October 31, 2024  
File No. 27224420.00

Mr. Mike Smith, P.E.  
Iowa Department of Natural Resources  
Land Quality Bureau  
6200 Park Avenue  
Des Moines, Iowa 50321

Subject: Request for Permit Amendment  
Revised Groundwater Underdrain System  
Loess Hills Regional Sanitary Landfill  
Permit No. 65-SDP-01-72  
Project No. 27224420.00

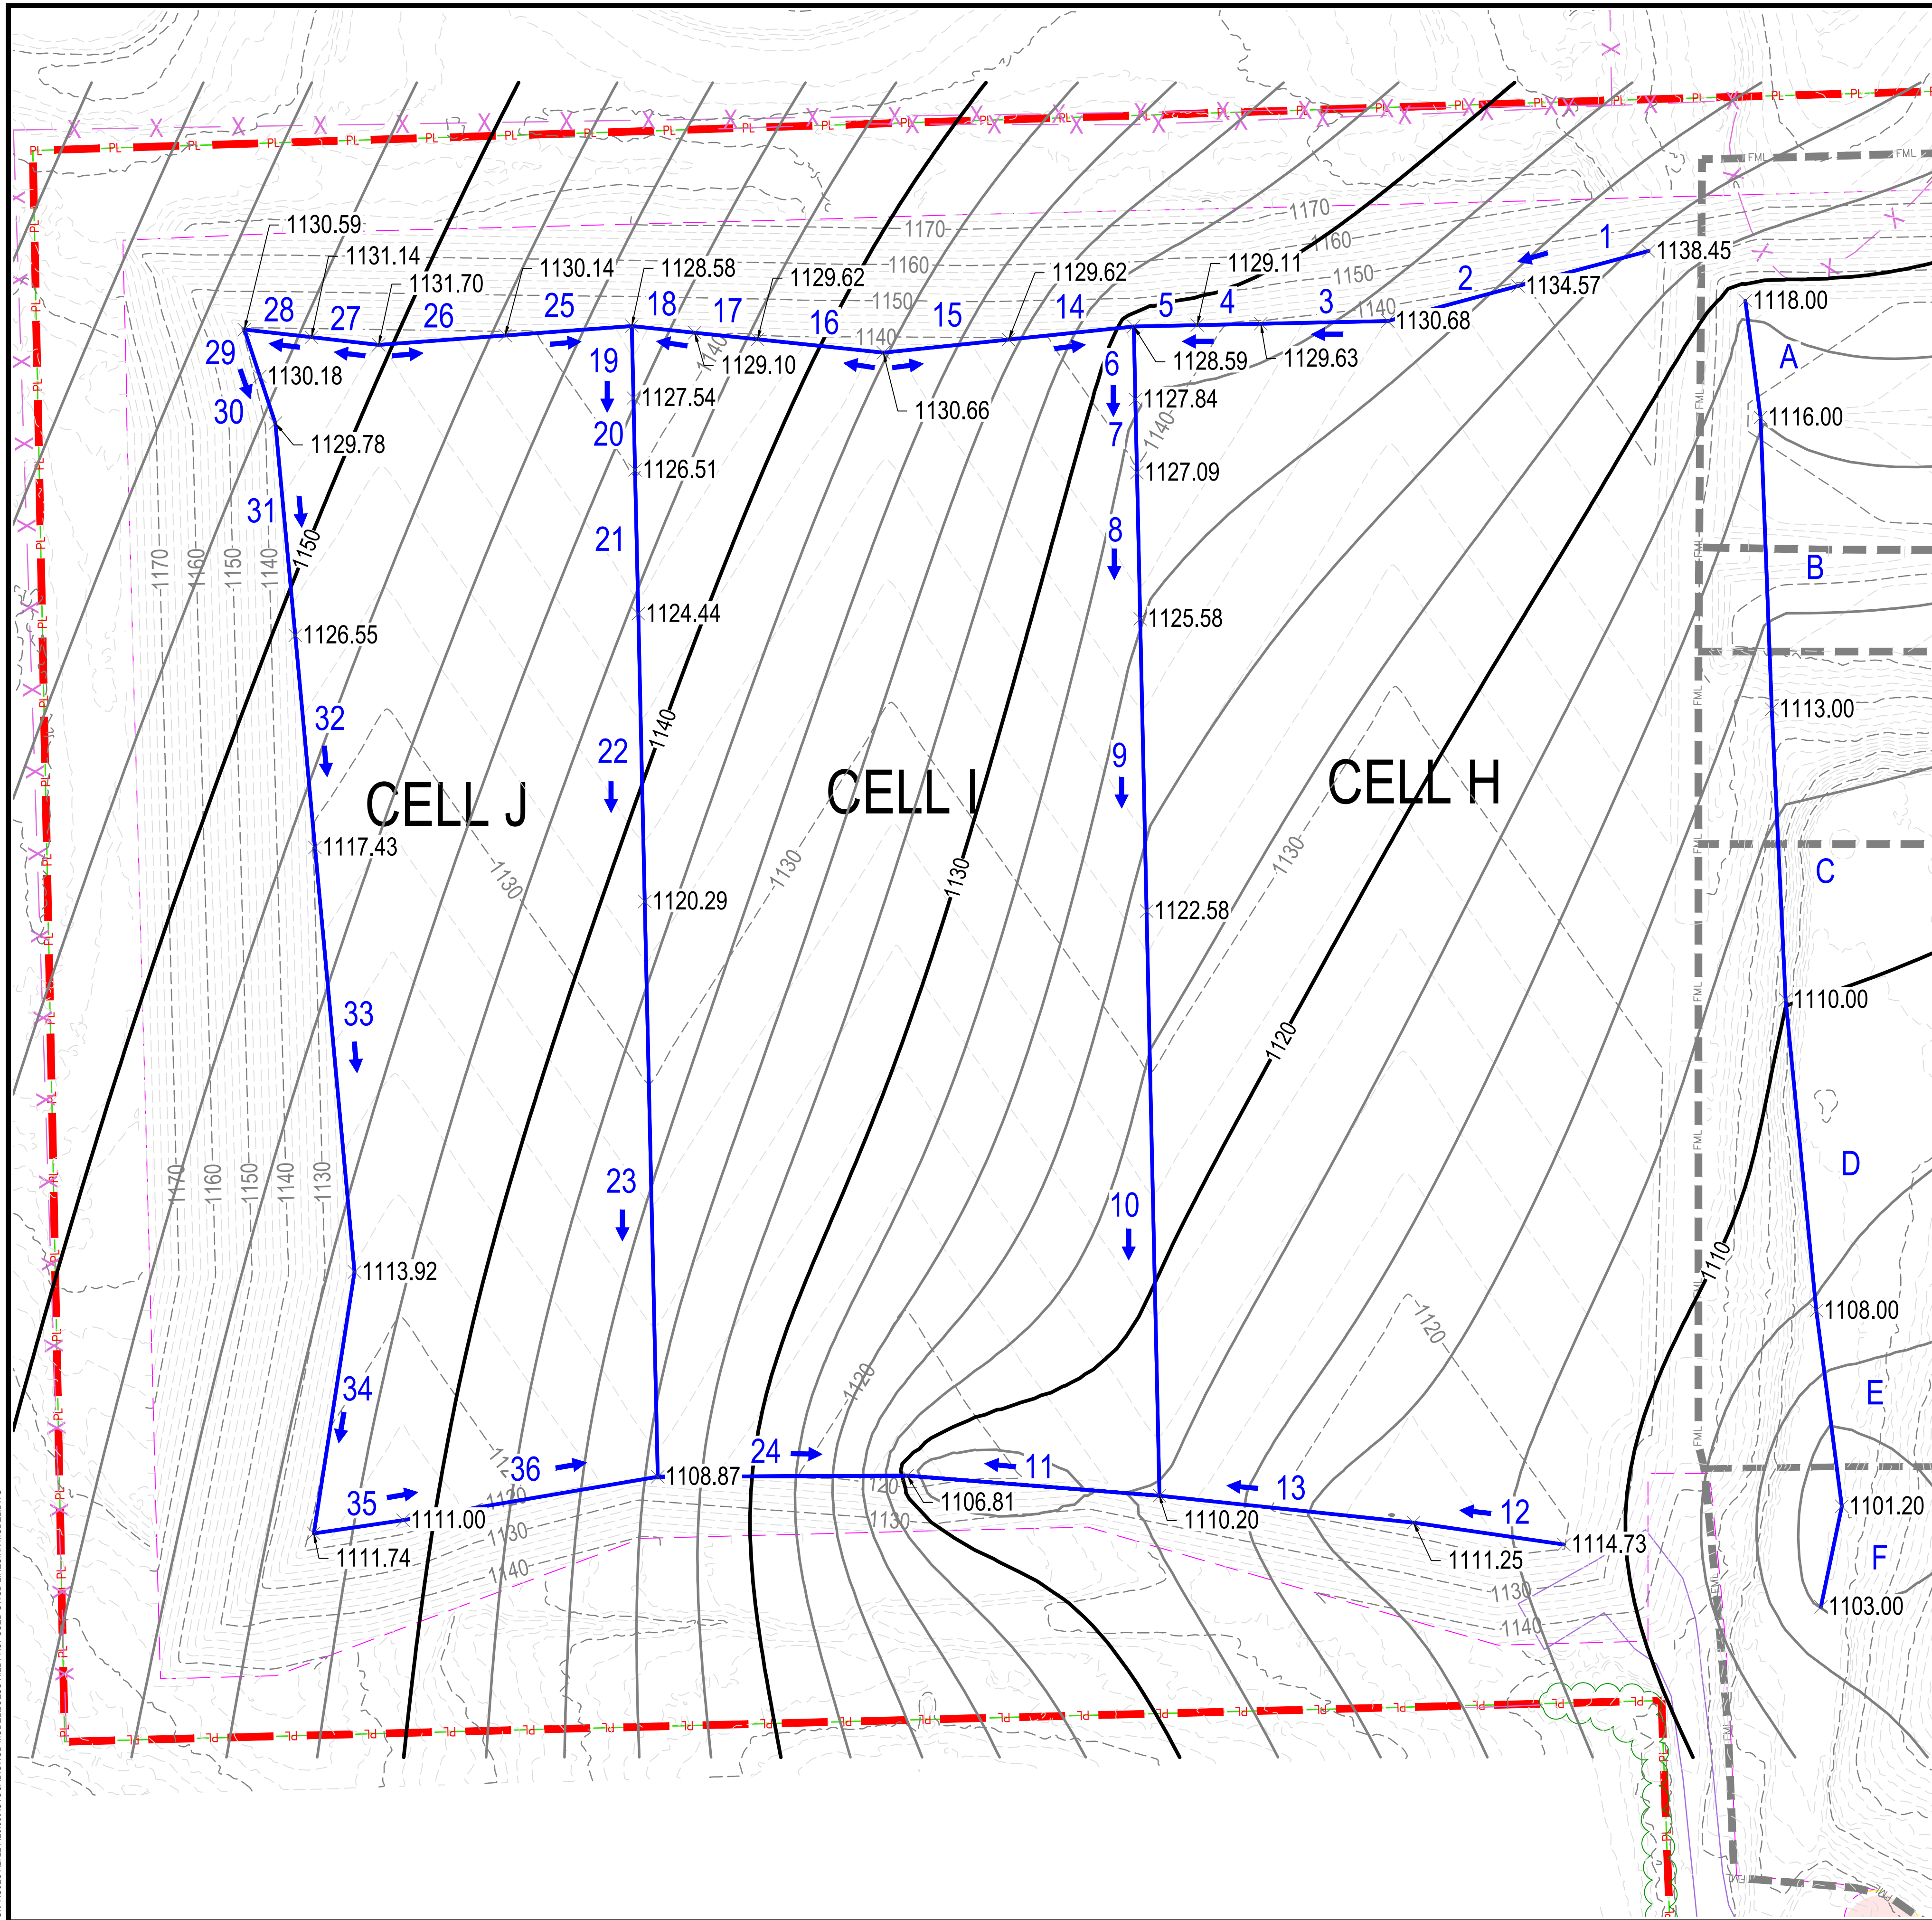
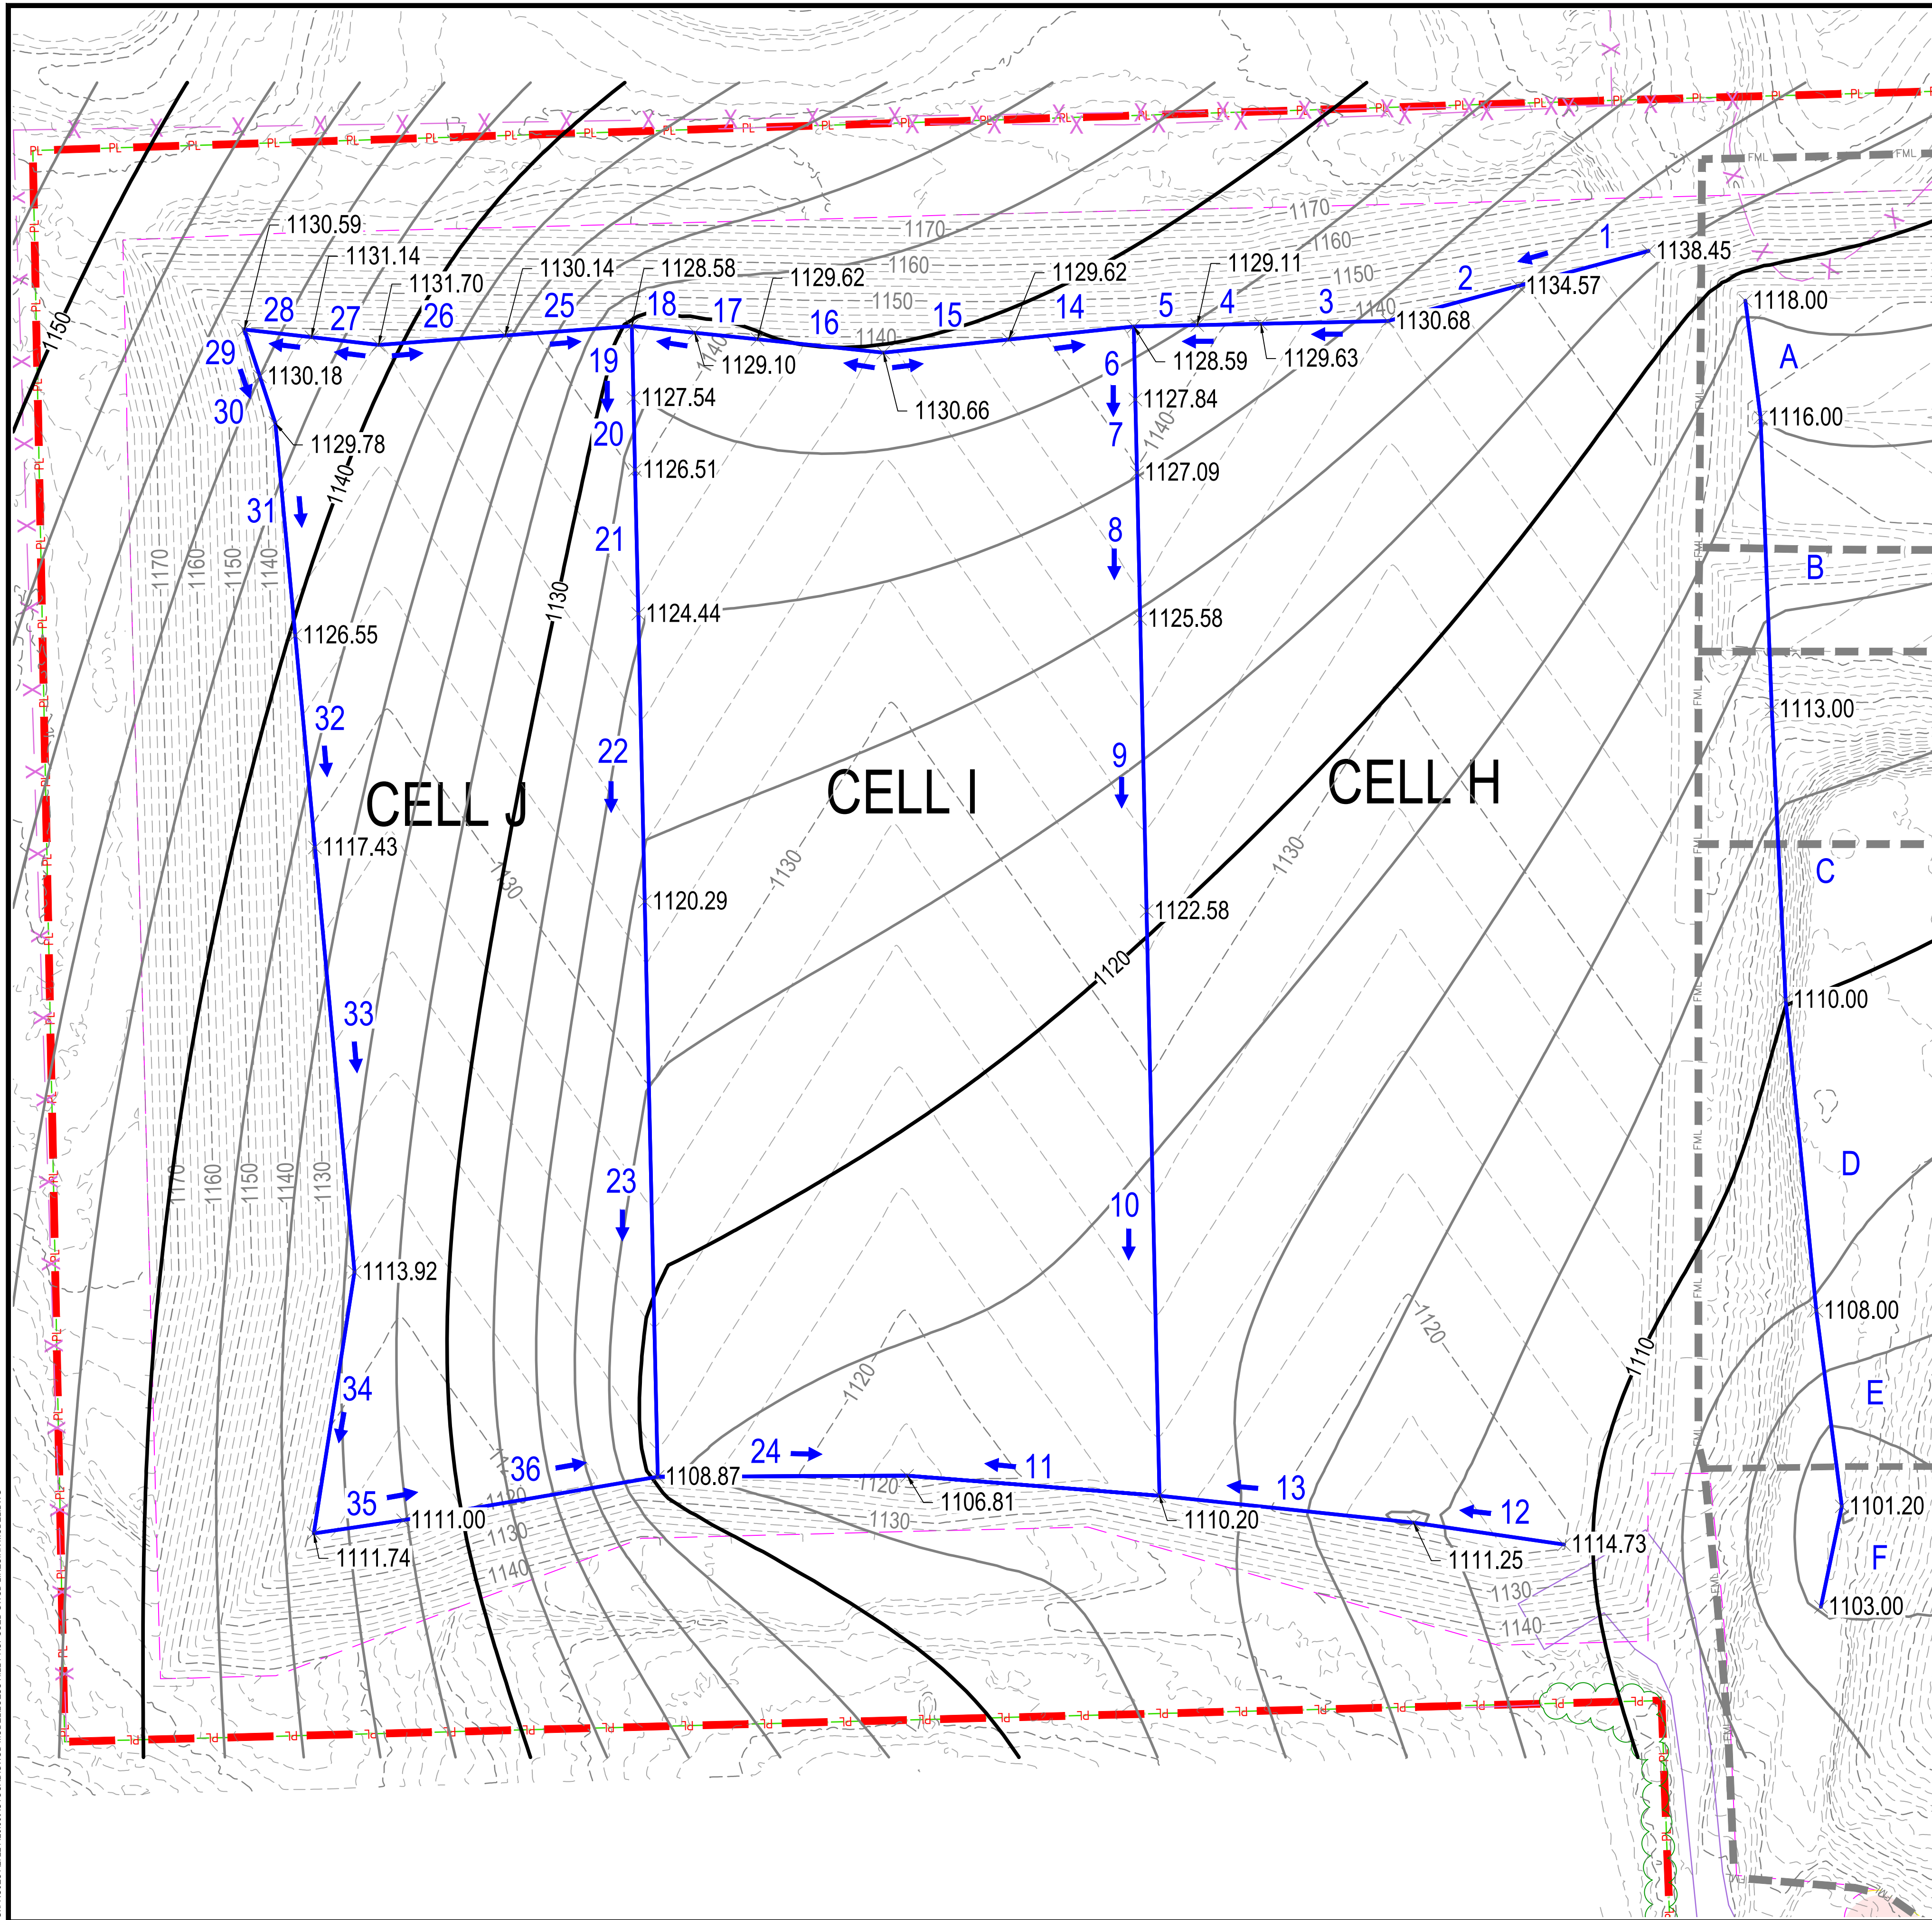
The collection trenches generally flow from west to east and north to south at a 1.0% slope. The flow trenches terminate at a sump that is outside of the limits of Cell H, but will be below the south end of future Cell I. This was done to allow for one sump/pump to dewater the full build-out of Cells H, I, and J.

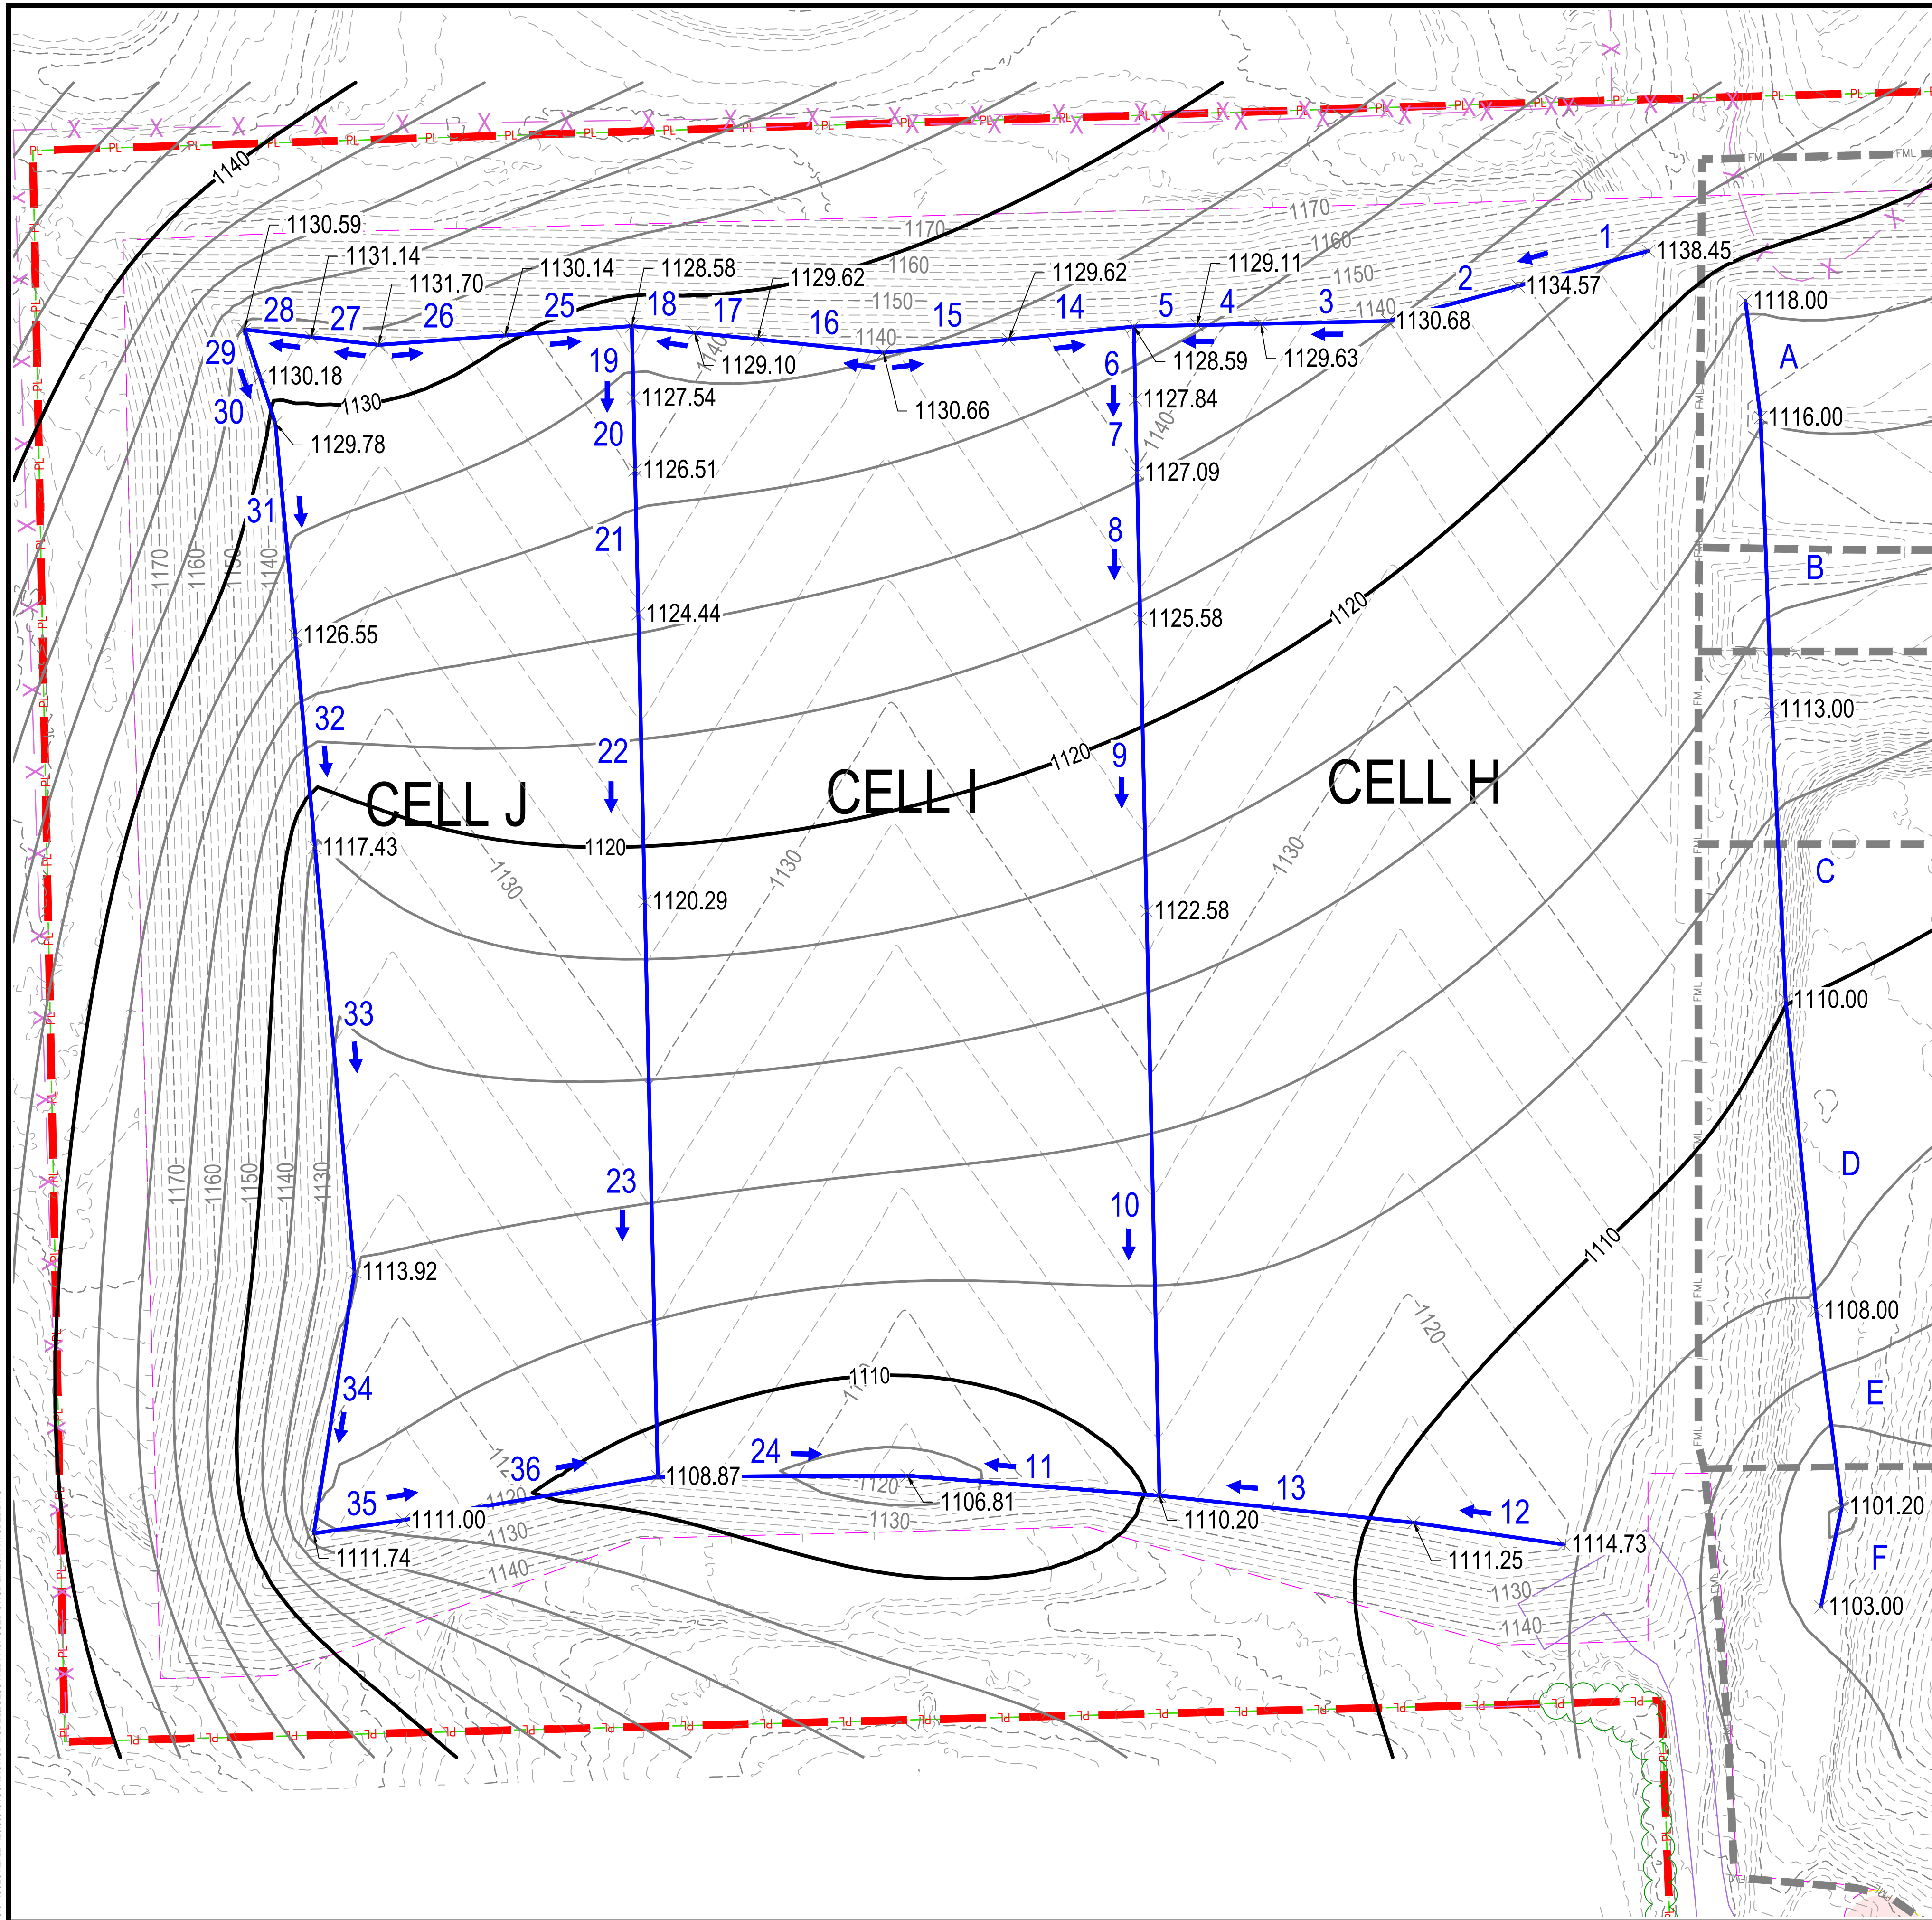
The north line sinks (14-17) split flow directions at the low point of the cell (the leachate collection trench) to minimize the drop needed to flow to the north-south line sinks that flow south. The new westernmost line sinks (19-23) flow to line sink 24 at the south edge of the cell, which then flows to the sump installed as part of Cell H construction.
